Southern Nuclear Operating Company
Vogtle Early Site Permit Application
Safety Review Site Audit Hydrology Information Needs

Enclosure: Responses to NRC Site Hydrology Information Needs From January 2007 Safety Review Site Audit For the Vogtle ESP Application

Information Needs from the January 2007 Safety Review Site Audit

Item #1 Figure 1

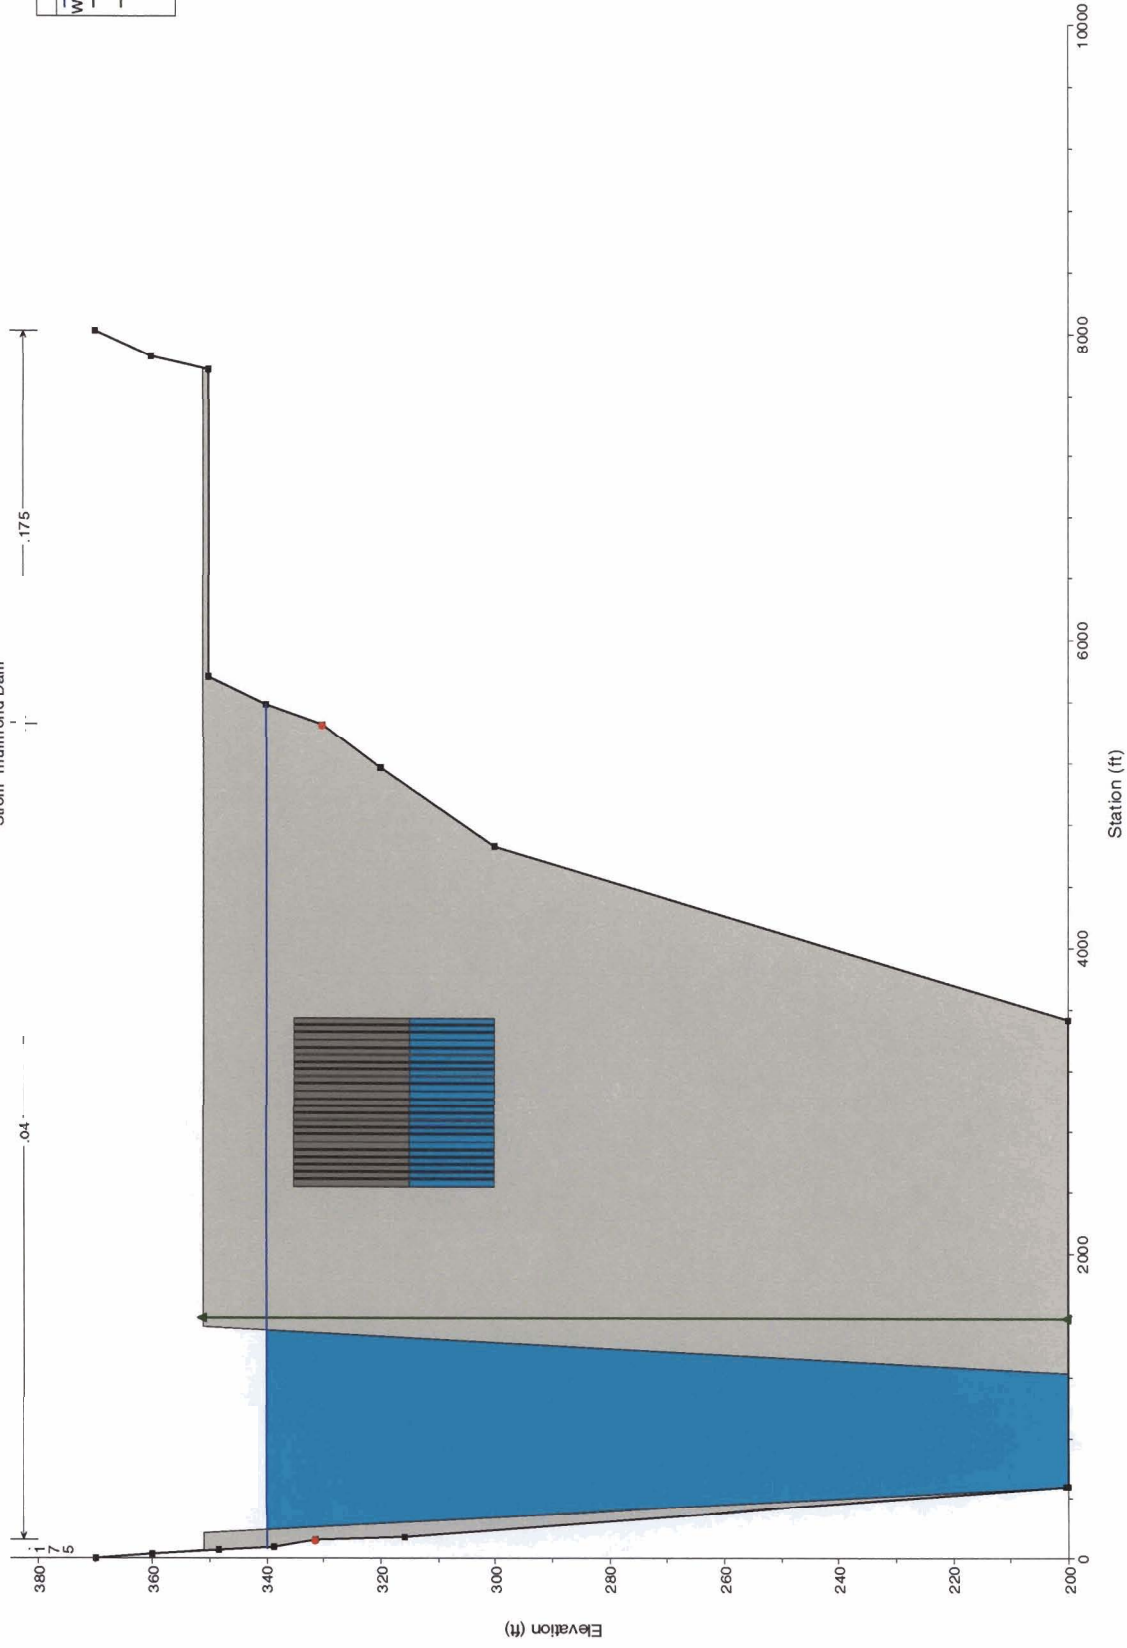
Item #1 Present the calculations used to estimate the dam breach parameters discussed on page 2.4.4-4 and outlined in the USBR.

- 2) As shown on Item #1 Figure 1 of this response, the total dam width at the top of the dam is about 5,700 ft. (Reference 2). The width of the dam at the upstream invert elevation (El. 200 ft) is about 2,840 ft. Located within the portion of the dam that extends to El. 200 ft is a concrete embankment section 2,282 ft wide where the tainter gate spillways and powerhouse are located (Reference 2). The failure mode assumes that only the earth section of the dam will erode during the breach. Consequently, the 755-foot bottom width of the breach extends beyond the area in which the actual ground elevation is at the minimum ground elevation of El. 200 ft.

- 3) Superposing the 755-foot bottom width at El 200 ft on the cross-section of the valley on the upstream side of the dam shows that more than 200 feet of the breach would be above El. 200 ft. Therefore, the entire bottom of the breach was taken as El. 200 ft to be conservative. The cross section shown in Figure 1 has been artificially widened at El. 200 ft to accommodate the 755 ft wide breach.
